"ANTENNA CAP, ANTENNA CONNECTORS AND TELEPHONE

LINE CONNECTORS FOR COMPUTER DEVICES UTILIZING

AMENDMENT

Responsive to the Official Action of October 13, 1995, please amend the above-identified application as follows:

FIG. 2A

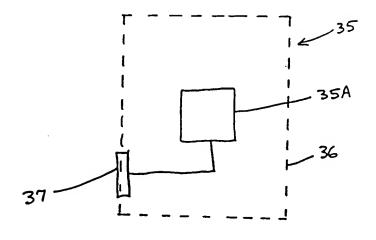
The Examiner has also objected to the drawings under 37 C.F.R. Sec. 1.83(a), indicating that the radio, cellular phone, and modem inside the card must be shown or the feature canceled from the claims. With this Amendment, Applicants submit new drawing figures 2A, 2B, and 2C, and accompanying description to illustrate the claimed features. Figure 2A illustrates a radio card (10) having a radio transceiver (10A) within its housing (13), electrically connected to an antenna contact block (17). This configuration is supported in the specification as filed at page 7 lines 10-21. Figure 2B illustrates a modem card (35) having a modem (35A) within its housing (36), electrically connected to a contact block (37). This configuration is supported in the specification as filed at page 8 lines 13-17. Figure 2C illustrates a modem card (35) having a modem (35A) and a cellular phone (38) within its housing (36), electrically connected to a contact block (39). This configuration is supported in the specification as filed at page 8 lines 13-17. Applicants therefore urge that new drawing figures 2A, 2B and 2C contain no new matter and show the claimed radio, cellular phone, and modem features, and respectfully request that the Examiner withdraw the objection to the drawings under 37 C.F.R. Sec. 1.83(a).

- 1. The drawings are objected to because of informalities stated on PTO-948 form. The drawings for figure 27 and 28 do not correspond to the specification on pages 9 and 10. Correction is required.
- 2. The drawings are objected to under 37 C.F.R. § 1.83(a). The drawings must show every feature of the invention specified in the claims. Therefore, the radio, cellular phone and modem inside card must be shown or the feature cancelled from the claim. No new matter should be entered.

--Fig. 2A is a block diagram of a radio card containing a radio transceiver in accordance with the present invention;

--Referring to Fig. 2A, a radio card (10) is shown in accordance with the present invention. The radio card (10) has a housing (13) and contains a radio transceiver (10A). The radio transceiver (10A) is electrically connected to an antenna contact block (17), which may for example be a pair of antenna contacts (15, Fig. 2). The radio card (10) may optionally have additional antenna contacts (see 20, Fig. 1) electrically connected to the radio transceiver (10A). The radio transceiver (10A) is not shown in Fig. 2A to scale, nor are the relative positions of the radio transceiver (10A) or the antenna contact block (17) on the radio card (10) drawn for accuracy; Fig. 2A is a block diagram intended only to show functional blocks of the radio card (10).
